Three Mile Island Nuclear Station, Unit 1 (TMI-1)
Operating License No. DPR-50
Docket No. 50-289
ATWS Implementation (10 CFR 50.62)
RAI Meeting - Post Meeting Questions

Response to Enclosure 2 to the NRC letter dated February 27, 1989.

"Post-Meeting Questions on TMI-1 ATWS Systems"

TABLE 1

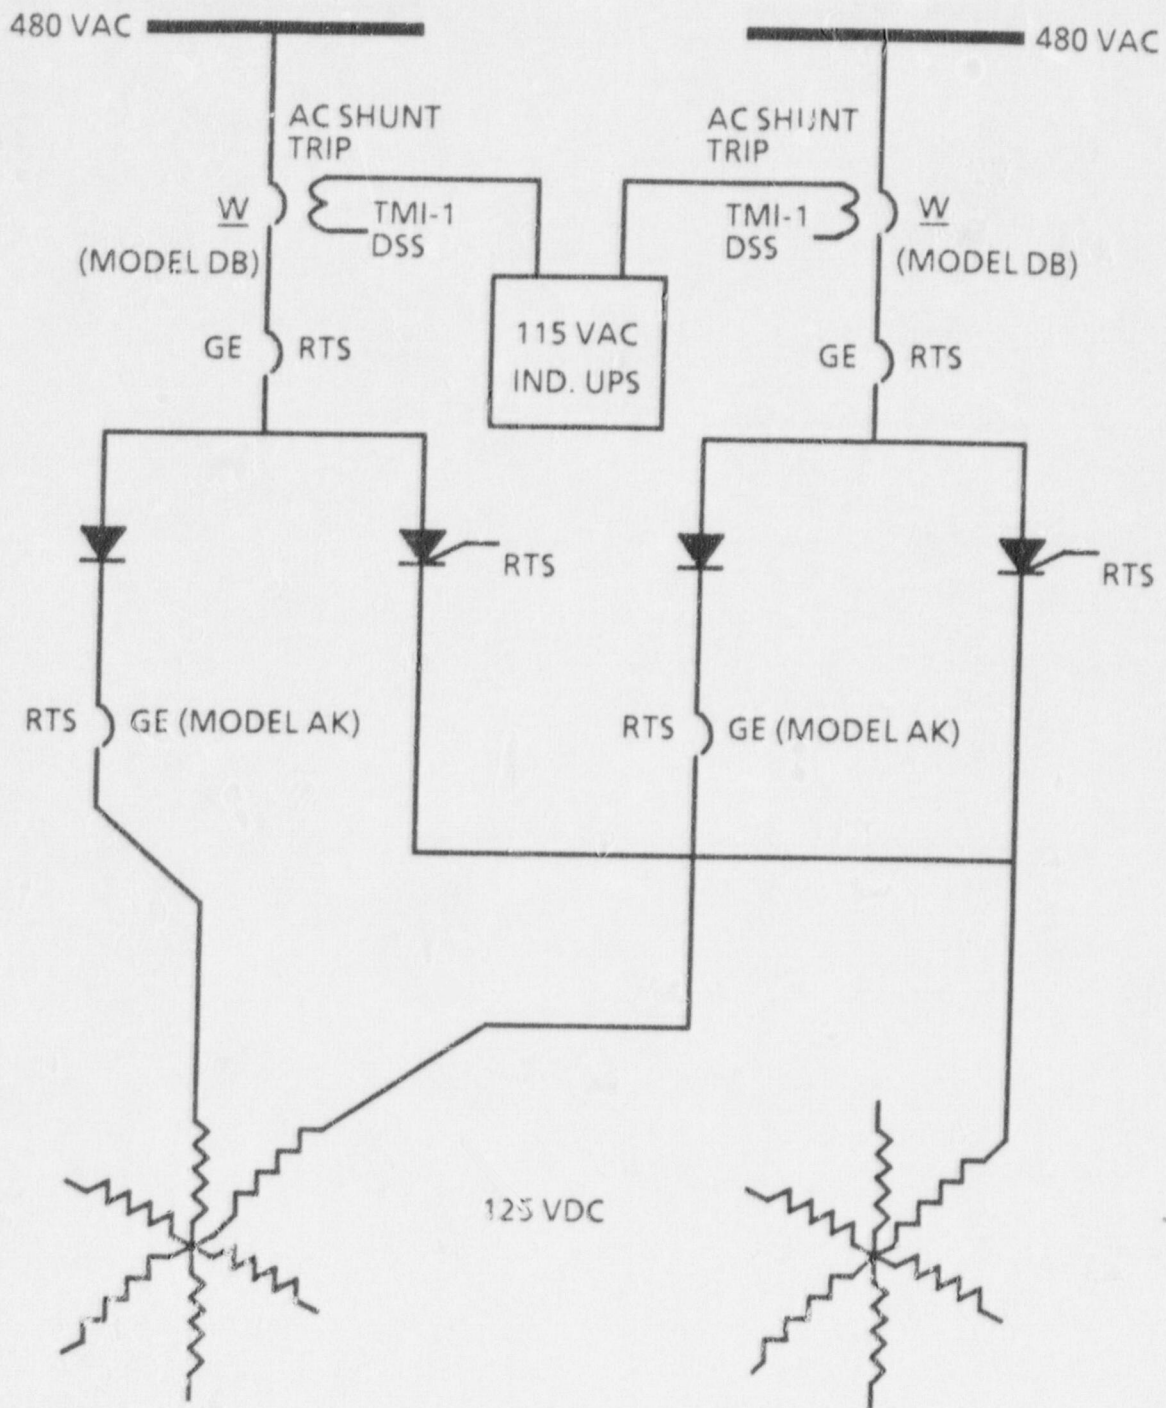
Provide information regarding the physical and operating characteristics of the Westinghouse circuit breakers being considered for use in the revised ATWS/DSS design and the existing General Electric circuit breakers that are currently used to interrupt power to the CRDMs at TMI-1. Include in this discussion information regarding the differences of the devices used to trip the circuit breakers and the type and voltage level that is used to operate these tripping devices.

Diversity is the major design criteria to be met by the ATWS DSS. The diversity of interest is between the Westinghouse breaker and the SCR de-gate and also between the Westinghouse breaker and the General Electric (GE) breaker, as the RTS utilizes the SCR de-gate and the GE breakers to remove power from the CRDMs. The Westinghouse breakers (DSS) and SCR de-gate (RTS) are quite diverse in both hardware design and function. There is a general diversity between the Westinghouse and GE breakers from a manufacturing viewpoint and a specific diversity in the manner in which each accomplishes its trip function. The RTS-GE breakers interrupt 125 VDC to the CRDMs while the DSS Westinghouse breakers interrupt 480 VAC. See Table 1.

The GE breaker utilizes an undervoltage trip coil (120 VAC) and a 125 VDC shunt trip coil controlled from a control relay which is actuated by the loss of the same 120 VAC. The Westinghouse breaker will utilize a 120 VAC shunt trip coil powered by the new independent power source for the DSS/AMSAC logic. The GE breaker (model: AK-2-15) and the Westinghouse breaker (model: DB-25) are depicted on Figures 2 and 3, also attached. The specific differences of interest are the methods of releasing the springs which open the moving arc contacts. The GE breakers utilize rotation of a trip shaft to release the opening spring. The Westinghouse breaker actuates a trip bar in a straight line to release the opening spring.

MANUFACTURER MODEL	WESTINGHOUSE DB-25	GENERAL ELECTRIC AK-25 (AK-15)
Location	1G Bus Unit 2A; 1L Bus Unit 2A Control Building 322' Elev.	CB1; CB2; CB3; CB4 Control Building 338' Elev.
IM Procedure	E-5	E-36
Vendor Manual	VM-TM-0283	VM-TM-0035
System Voltage	480V AC	120V DC
Control Voltage	125V DC	125V DC/120V AC
Voltage Rating	600V AC/250V DC	600V AC (250V DC)
Current Rating	600 Amps	600 Amps (250 Amps DC)
Overcurrent Tripping Device	Solid State (Amprector)	None
Operating Mechanism	Manual	Solenoid
Auxiliary Switches	None	2 Aux. Contact Blocks 1-Mech. and 1-Elect.
Shunt Trip	120V AC	125V DC
Undervoltage Trip	None	Undervoltage Trip 120V AC
